APPLICATION NO.	FILING DATE	FIRST NAMED INVENTOR	ATTORNEY DOCKET NO.	CONFIRMATION NO.
10/520,798	08/10/2005	Lin Xiang Sun	0299568-0420-PCT-US	9959
22469 7590 07/10/2008 SCHNADER HARRISON SEGAL & LEWIS, LLP 1600 MARKET STREET SUITE 3600 PHILADELPHIA, PA 19103			EXAMINER SCHEUERMANN, DAVID W	
			ART UNIT 2834	PAPER NUMBER
			MAIL DATE 07/10/2008	DELIVERY MODE PAPER

Office Action Summary

DETAILED ACTION

at least one permanent magnet separated from one of: i) said stator and ii) said rotor by a second magnetic air gap; (see figure 2a labeled below)

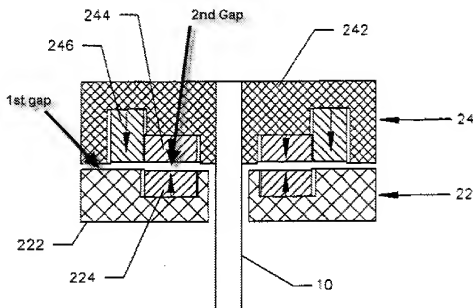
A thrust load enhancement device for a rotor-bearing system, comprising

a stator 22 mounted on a rotation axis of the rotor-bearing system;

a rotor 24 separated from said stator by a first magnetic air gap on the rotation axis; and

wherein said at least one permanent magnet, said stator and said rotor form a magnetic circuit characterized by a flux path, a flux in said first and

second air gaps generating a compensation force between said rotor and said stator that opposes an external force F_{ext} . (inherent since the gaps remain substantially constant)

Re claims 3 and 22, note that the permanent magnet 224, supra, is separated by 2nd gap.
